# ADA Curb Ramp New Construction Inspection Form (Parallel)

NW Timeric

23885.56

NW Lenox

PARALLEL RAMP (PL)

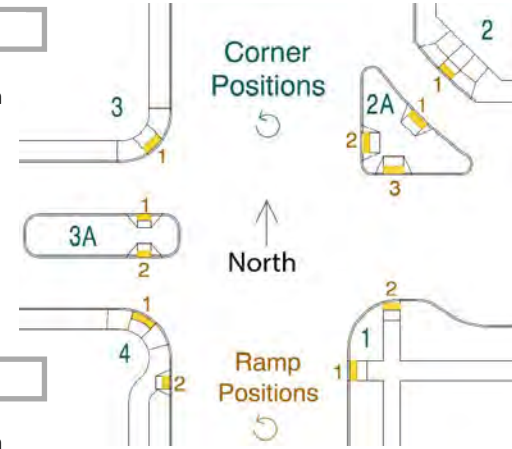
Y ☐ N ☒

$\leq 1/4"$  ☐  $> 1/4"$  ☒

12.9  $\leq |5.0\%|$  ☐  $> |5.0\%|$  ☒

4.1  $\leq 2.0\%$  ☐  $> 2.0\%$  ☒

10  $\leq 2.0\%$  ☐  $> 2.0\%$  ☒

NO DWS Fail RR and Turn Space
